## **KAKINADA-SRIKAKULAM PIPELINE PROJECT (PHASE-I)**

**CORRIGENDUM # 2**

**USM / TURBINE BASED METERING SKID**

***Bid Document No.: 05/51/23QC/APGDC/030***

CORRIGENDUM #2

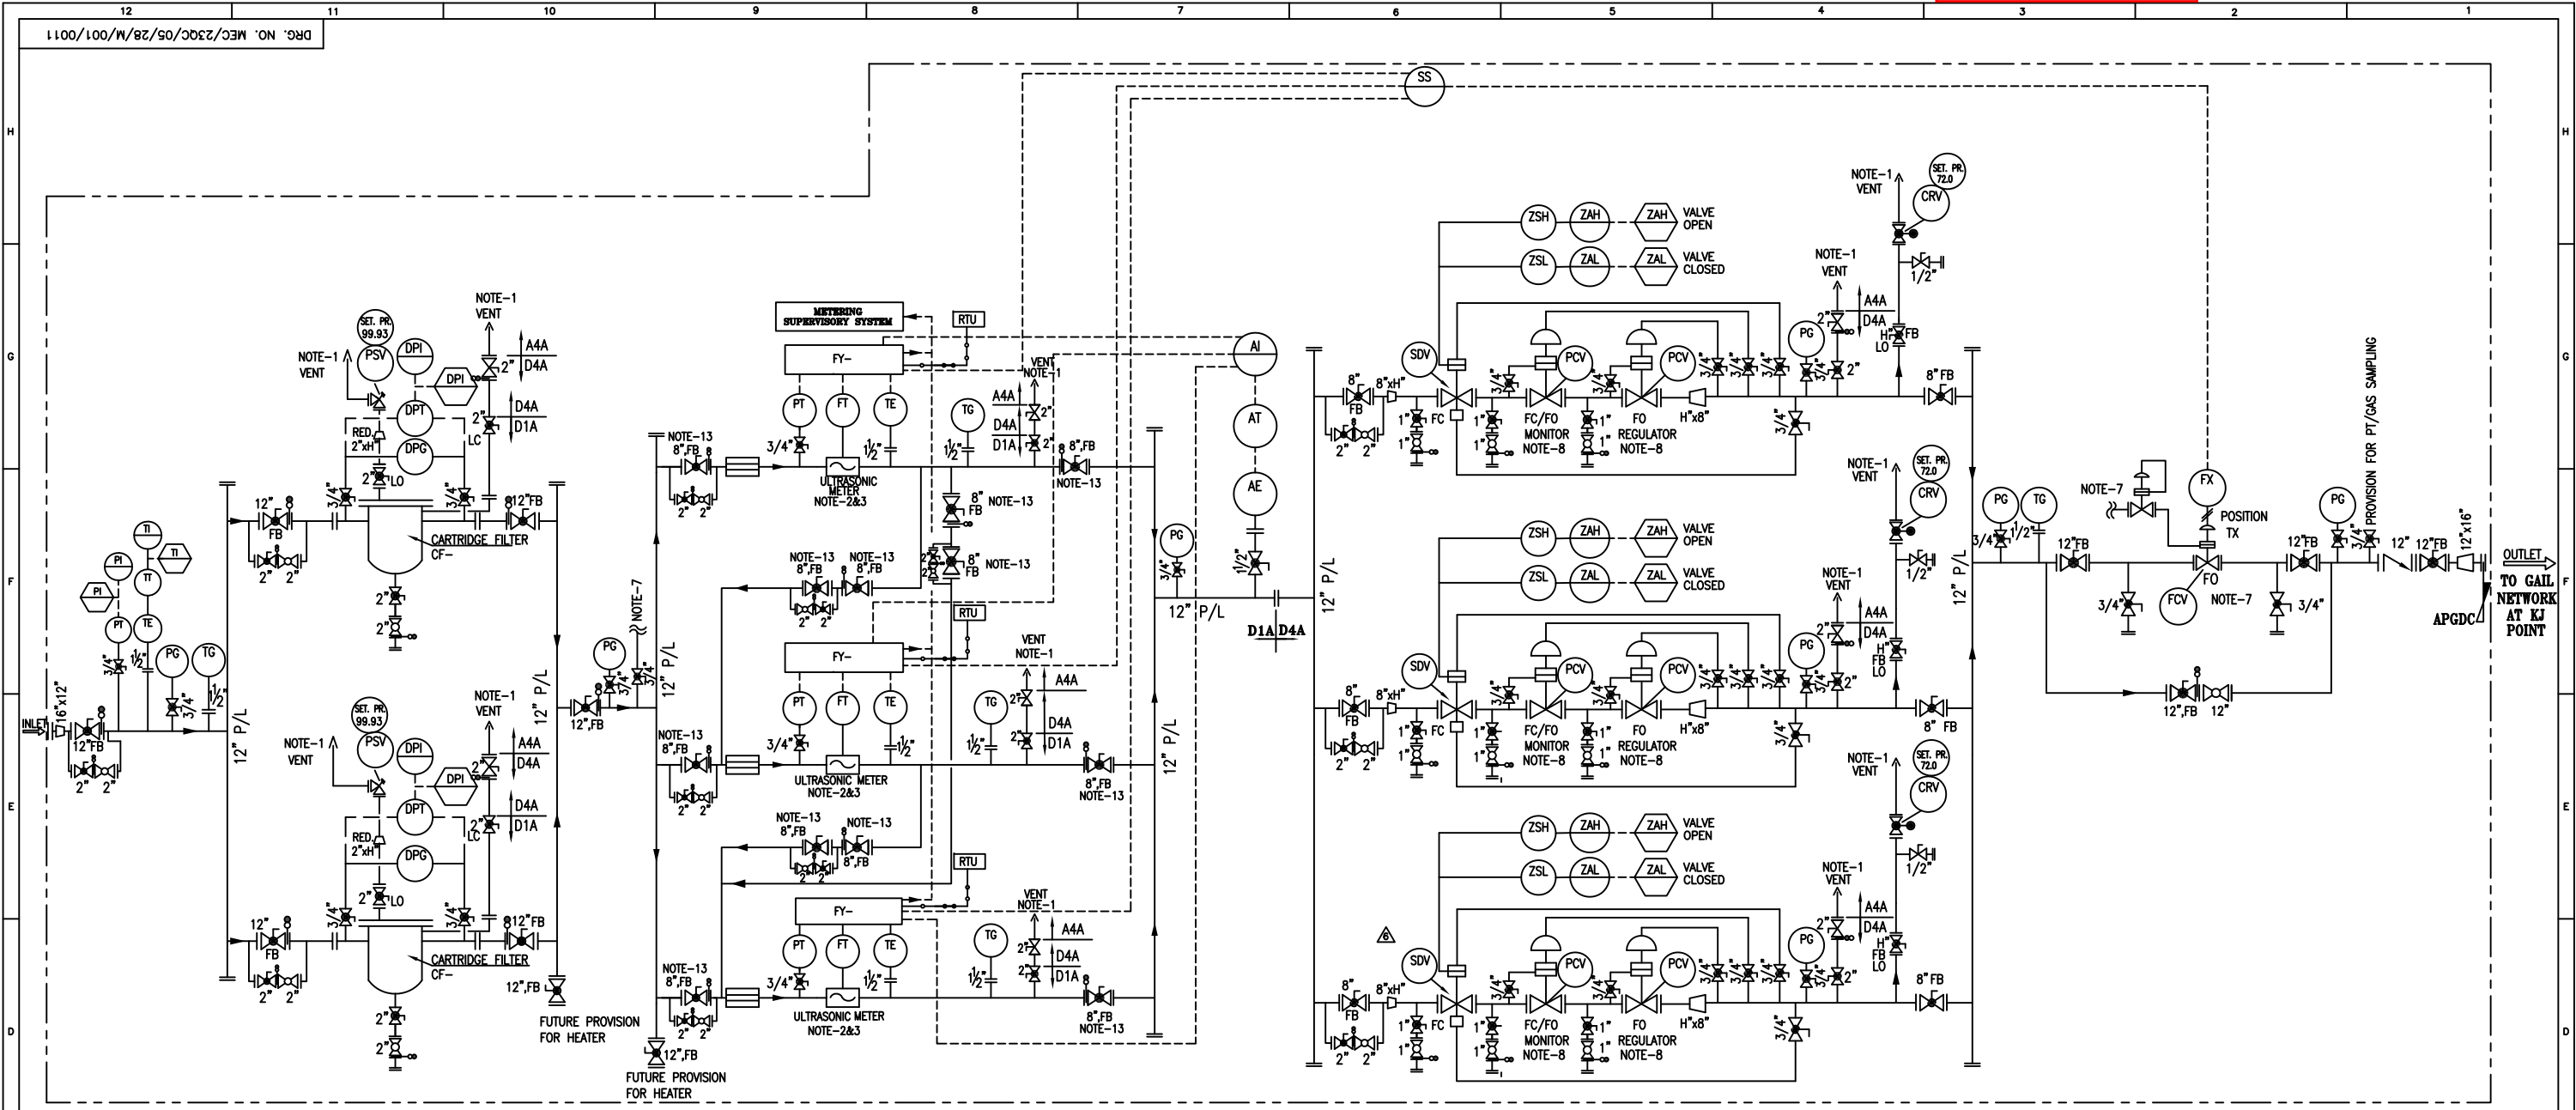
Sl. No.	Description	Volume	Page No.	Clause / Para / Section	Amendment / Addition / Modification / Deletion	
1	P&ID	II of II	213 of 633	-	Modification	Revised P&ID of KJ Point is attached as annexure-1 to the corrigendum.
2	Datasheet of Diff. Pressure Gauge	II of II	-	-	Addition	Datasheet of Diff. Pressure Gauge is attached as annexure-2 to the corrigendum.
3	Datasheet of Check Valve, Globe Valve, Ball Valve	II of II	-	-	Addition	Datasheet of Check Valve, Globe Valve, Ball Valve (7 nos. sheets) is attached as annexure-3 to the corrigendum.
4	MATERIAL REQUISITION	II of II	4 of 633	GROUP - C	Addition	LEL Detection System is in bidder's scope and specification attached with tender document shall be followed.
5	Heater Element	II of II	122 of 633	Clause no. 6.1	Deletion	The statement " the outer sheath of the heating elements shall be of alloy 800" stands deleted.
6	DATA SHEET FOR ELECTRIC PROCESS HEATER and CONTROL PANEL	II of II	111 of 633	Clause no. 23	Modification	The statement "20% of the (number) of Elements to be provided as unconnected spares" is modified to "3 nos. as spare".

7	ANNEXURE – V (APPROVED VENDOR LIST)	II of II	232 of 633	-	Addition	Following is added : "Suggested Vendors for DPG : 1) M/s AN Instruments Pvt. Ltd., New Delhi 2) M/s General Instruments Ltd., Mumbai 3) M/s WIKA"
8	MANDATORY SPARES	II of II	41 of 633	Clause no. 13.1	Addition	Following is added : "1 set of "Sensor Transducer assembly" is required for USM as Mandatory spare with each USM skid."
9	Reply to Pre Bid Queries	Clarification				The reply of pre bid queries is attached as Annexure-4 with this Corrigendum .
10	Date and time for submission of bid	I of II	5	1.9	Modification	Date and time for submission of bid for subject tender stands modified to: <b>"Upto 1400 hrs. (IST) on 10.10.2017"</b> Due Date & Time stated in cut-out slip shall stand modified to the above extent.
11	Date and time of opening of Un-priced Bids	I of II	5	1.10	Modification	Date and time of opening of Un-priced Bids for subject tender stands modified to: <b>"At 1500 hrs. (IST) on 10.10.2017"</b>
